**SECTION 96(2) MODIFICATION APPLICATION
ASSESSMENT REPORT
Four Points by Sheraton Hotel Redevelopment
161 Sussex Street, Sydney
(SSD 4972 MOD 3)**

Secretary's
Environmental Assessment Report
Modification of consent under section 96(2) of the
Environmental Planning and Assessment Act, 1979

September 2014

Figure 3: Proposed ground level floor plan (changes in red)

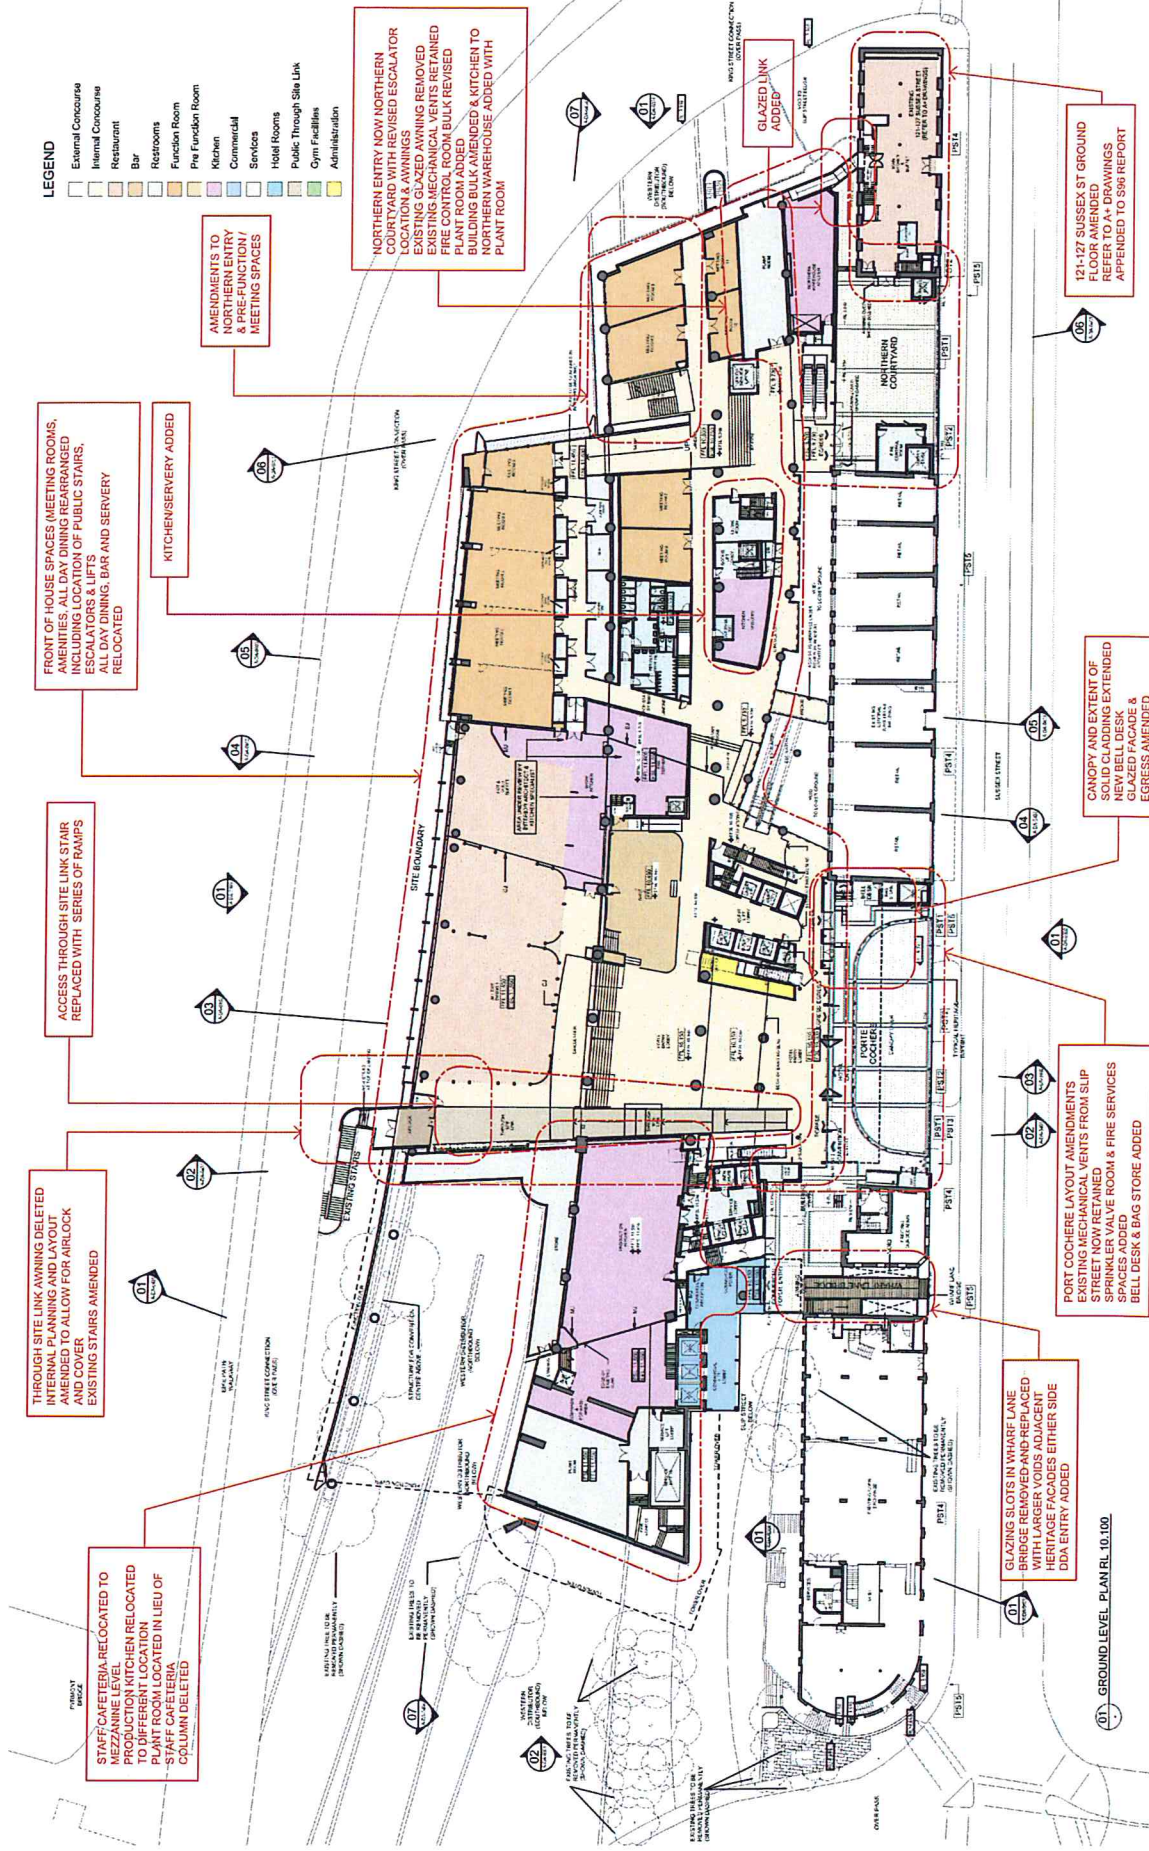
A number of design amendments mainly in relation to heritage interpretation are proposed to the approved Wharf Lane Bridge (**Figure 3** and **Figure 4**). These include amending the bridge to allow secondary ramp access to the Corn Exchange, replacing glazing slots with larger voids to increase visibility of the facades of the Corn Exchange and Dundee Arms Hotel and installation heritage ground inlays and balustrade structure display panels.

Having regard to the views of the Heritage Branch, and considering the proposed changes are designed to improve heritage interpretation, the Department is supportive of this aspect of the proposed modification.

Figure 6: Proposed convention and function building design

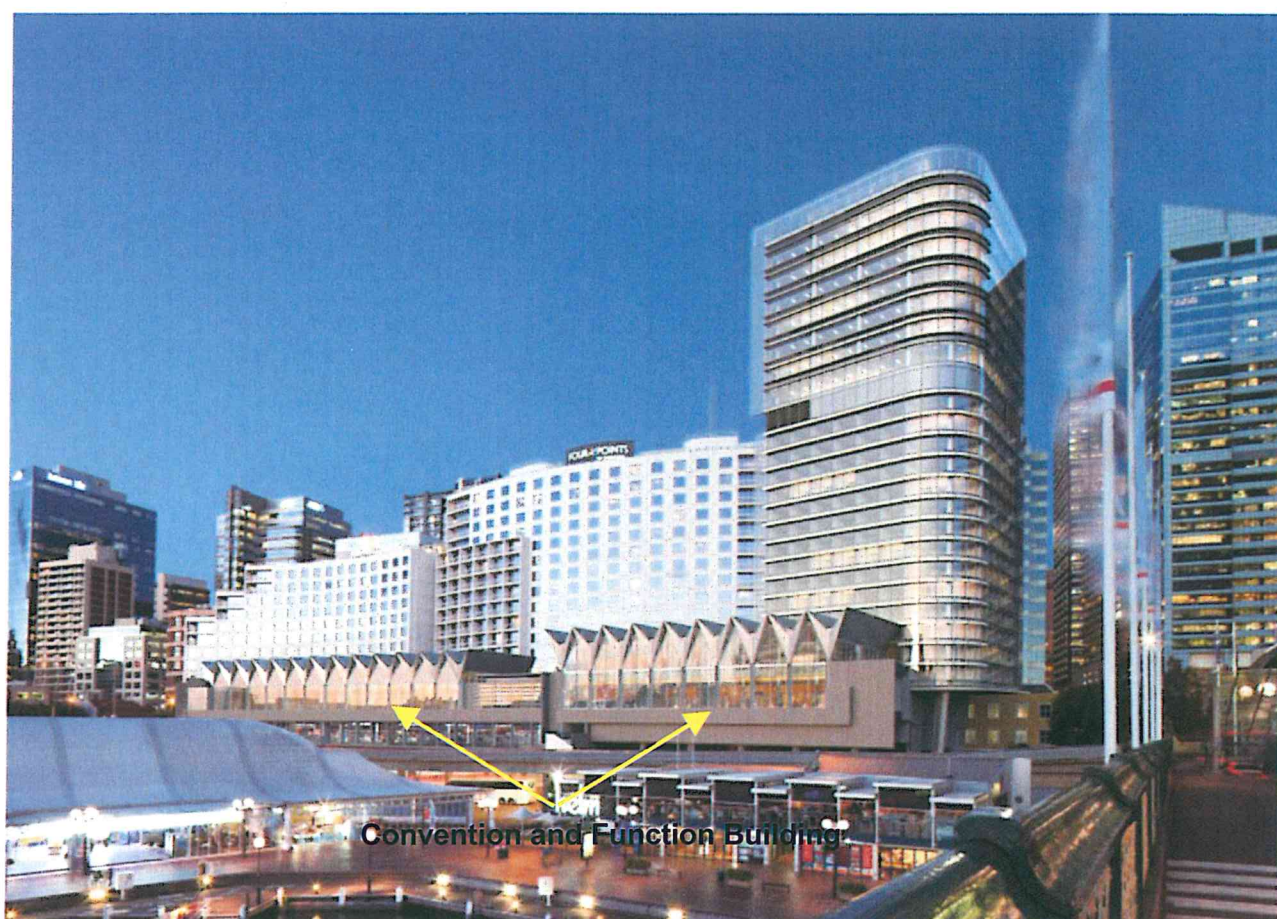
- changes to the extent and location of glazing on the western façade;
- use of zinc cladding along the western façade to offset the glazing and emphasise the 'sawtooth roof' design;
- use of Equitone panelling instead of GRC cladding;
- a minor change to the design and treatment of the building parapet along the 'sawtooth roof';
- revisions to the design of the central pre-function façade including the louvres, materials and roof design; and
- a 300mm increase to the height of the 'sawtooth roof' ridgeline on the northern function hall from Rating Level (RL) 25.50 to RL25.80 and to the southern function hall from RL27.40 to RL27.70.

Similar to the tower building, the proposed changes aim to simplify the façade detail, enhancing the horizontal appearance of the structure and make it more elegant in appearance.

Façade maintenance has also been considered in the revised design of the convention and function building. Recesses in the revised façade have been included to conceal building maintenance units and allow façade cleaning and maintenance to be conducted in a safe manner without the need to close the Western Distributor.

Advice on reflectivity effects prepared by AECOM and attached at Appendix F of the SEE also confirms that the modified function façade would also have lower reflectivity than the approved development and would satisfy the relevant reflectivity criteria in Condition C2 of the development consent.

The Department has reviewed the proposed changes to the convention and function building in detail and is satisfied that they would result in an improved design outcome. This is because the design would better integrate with motorway infrastructure, the new tower building and the public domain at Darling Harbour. Further, the Department considers the changes better respond to the needs of the hotel operator by allowing building maintenance to be conducted safely and more easily.

Figure 8: Proposed revised design of the through-site link from above (left) and from the hotel foyer (right)

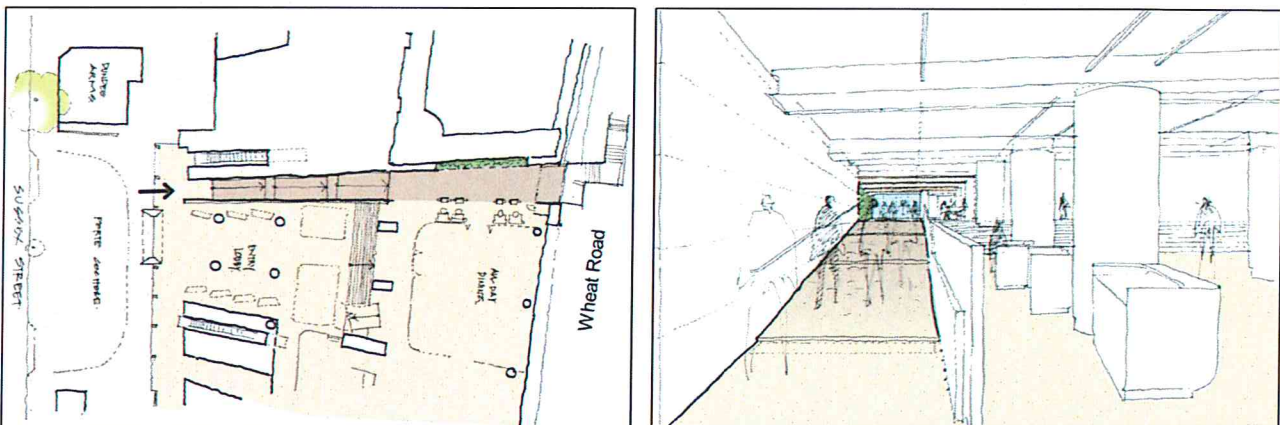
- replacing the existing stairs connecting Wheat Road to provide more direct access;
- increasing the landing space at the top of the stairs adjacent to the hotel entrance;
- removing stairs within the approved through-site link walkway and replacing them with a series of ramps to provide equitable access; and
- converting some ground level meeting rooms to a new dining area overlooking the through-site link (**Figure 8**).

To overcome this, the Applicant has revised the design of the through-site link to provide a series of ramps. The Applicant considers that the revised link design provides more equitable access (e.g. for person in wheelchairs) within the building through the use of ramps. The Applicant also considers that the revised design opens up the western entrance of the link to provide improved public access and clearer lines of sight from Sussex Street through to Darling Harbour.

Council considered that the revised through-site link should extend to the eastern exterior of the building in order to seamlessly integrate the public domain on Sussex Street with the Porte Cochere.

Council has since reviewed the RTS and advised the Department that it is satisfied with the response provided.

The Department is satisfied that the revised design of the through-site link is acceptable as it responds to impediments identified by RMS with the approved design and would provide an improved and dedicated public access through the site between Sussex Street and Darling Harbour.
